AGENDA

MATANUSKA-SUSITNA BOROUGH

ABBREVIATED PLAT AGENDA

September 30, 2026

PLAT OF:
ARLBERG SUBDIVISION
BLUE FLAME ACRES

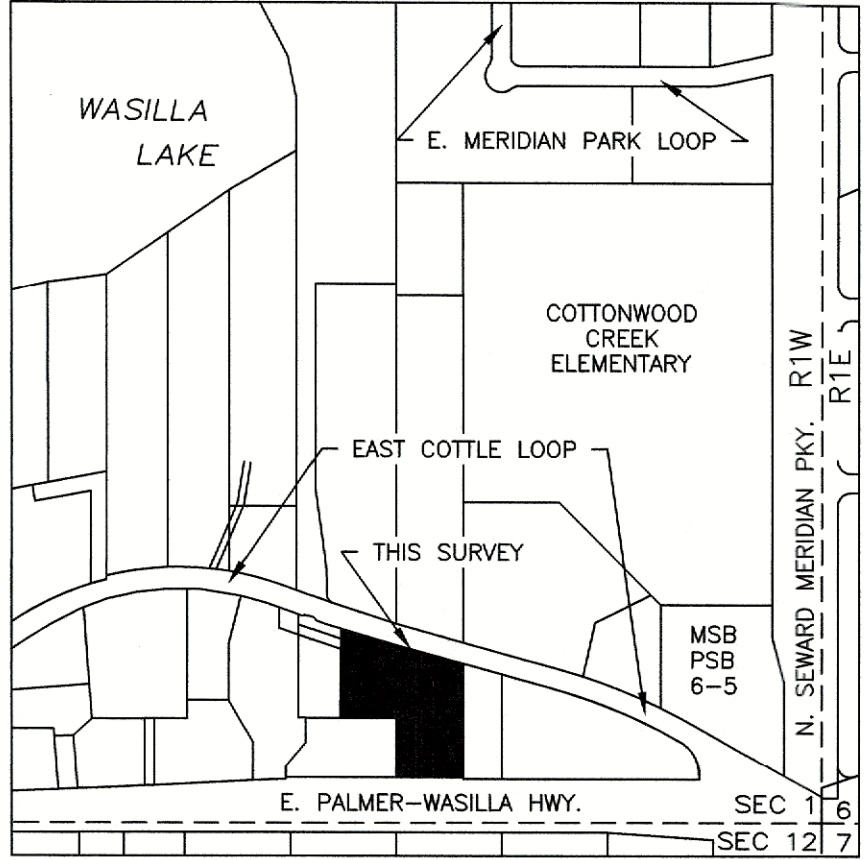
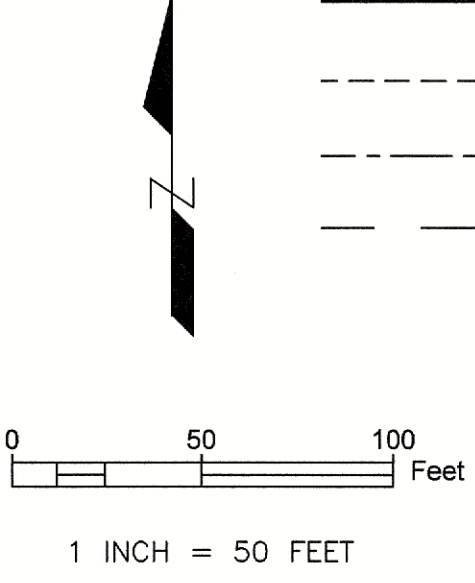
Comments: MSB Code Compliance (**Exhibit D**): “There are no open or active Code Compliance Cases on the existing lots at this time. The As-Built is showing two sheds that do not meet the setback requirements per MSB 17.55; as well as 8 (eight) Conex’s that appear to be within the required 10ft setback (no distance given on the as-built). Please make note of the setback requirements for the sheds & conex’s to be moved to meet the requirements.”

1. Pay postage and advertising fee.
2. Provide updated Certificate to Plat executed within 7 days prior to recording and provide beneficiary affidavits from holders of beneficial interest, if any.
3. Taxes and special assessments must be paid in full prior to recording the plat, per MSB 43.15.053(F) and AS 40.15.020. Pay taxes and special assessments (LIDs) by certified funds or cash.
4. Submit recording fee payable to DNR.
5. Ensure all structures meet setback requirements per MSB 17.55.
6. Submit final plat in full compliance with Title 43.

PLAT OF
KINSTEAD
A PLAT OF LOT 5, NORMAN LANGE'S HOLIDAY SUBDIVISION PLAT 11-329 PALMER
RECORDING DISTRICT, THIRD JUDICIAL DISTRICT, STATE OF ALASKA
LOCATED WITHIN
NE 1/2 OF SECTION 9, TOWNSHIP 18 NORTH, RANGE 2 EAST,
STANDARD MERIDIAN 44
CONTAINING 4.88 ACRES, MORE OR LESS

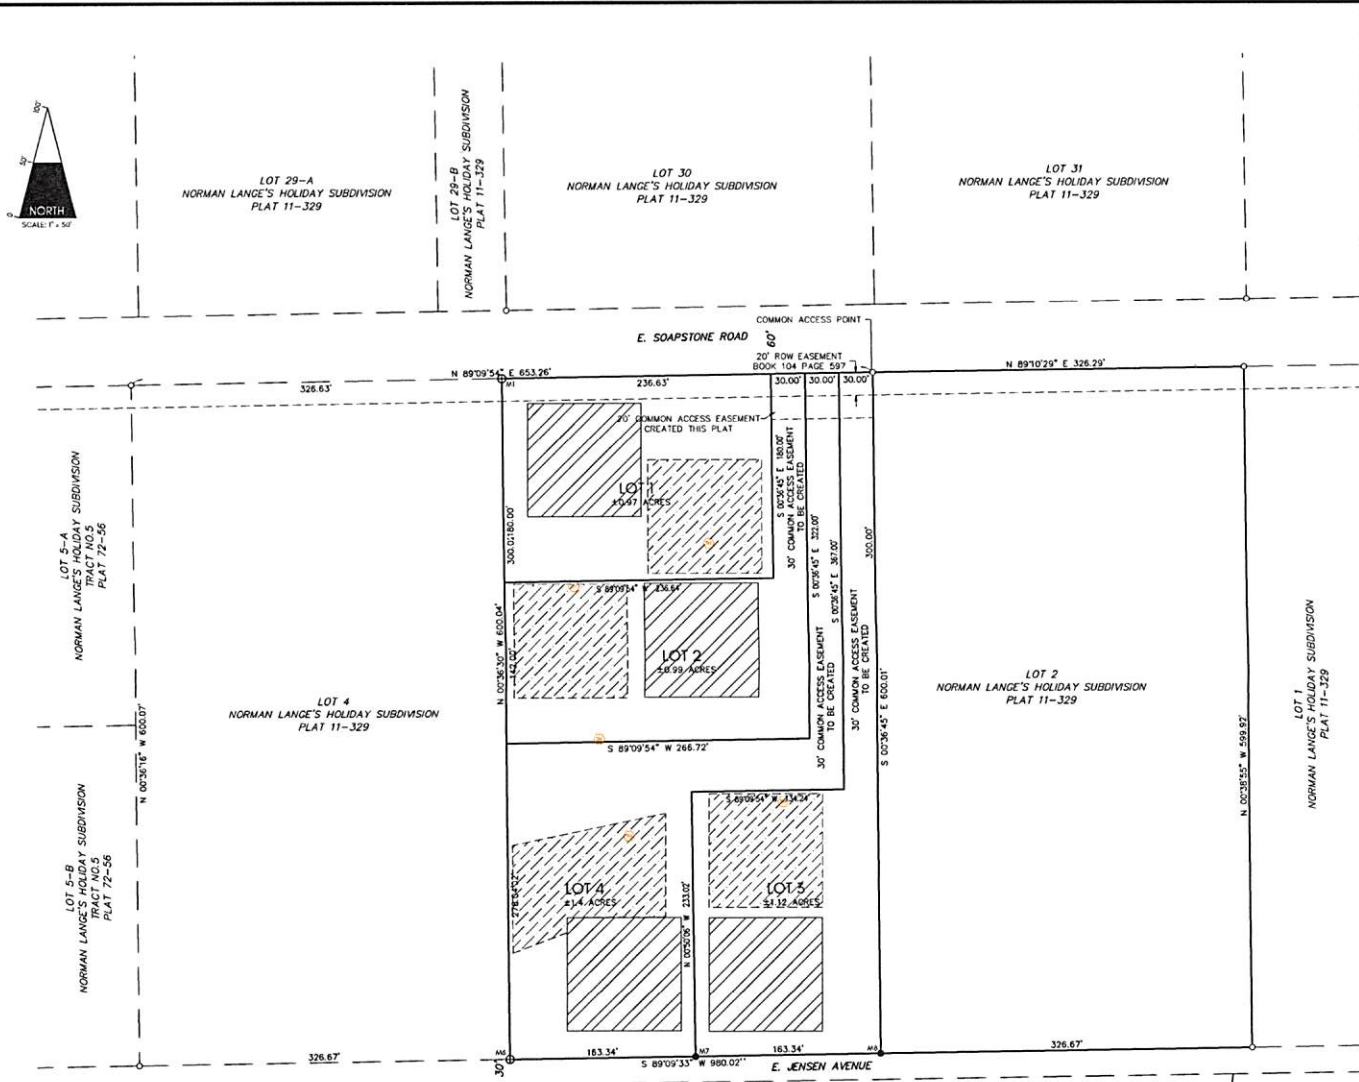
MTA would like to request the common access easements include utilities for service lines.
